TITLE ME 15 ASSY
 REV. C
 DRV. NO. 522-021

TITLE
ME15-ME30 SCHEMATIC

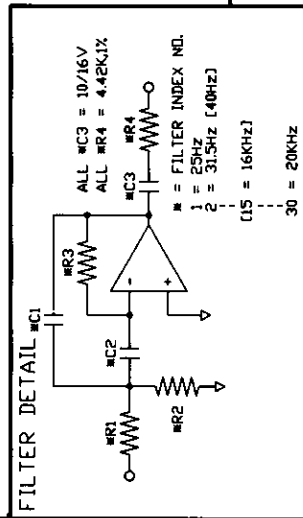
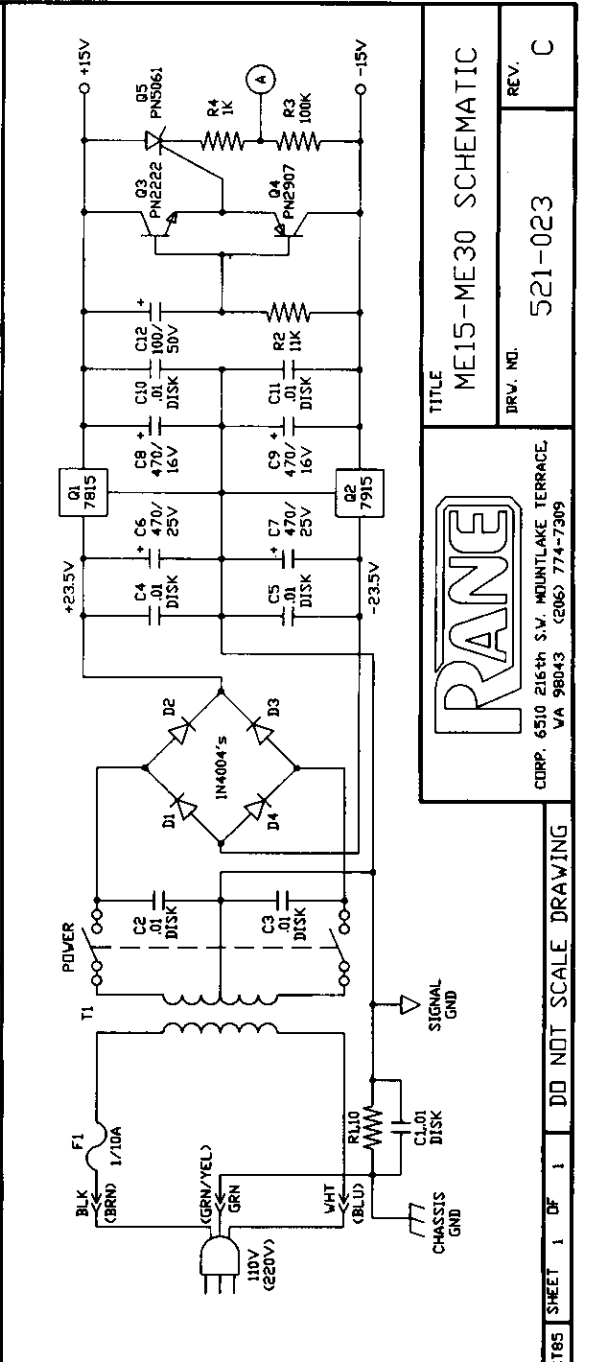
*C112 + C113 - CAN be changed
To Ferr. Beeds To Reduce
RFI*
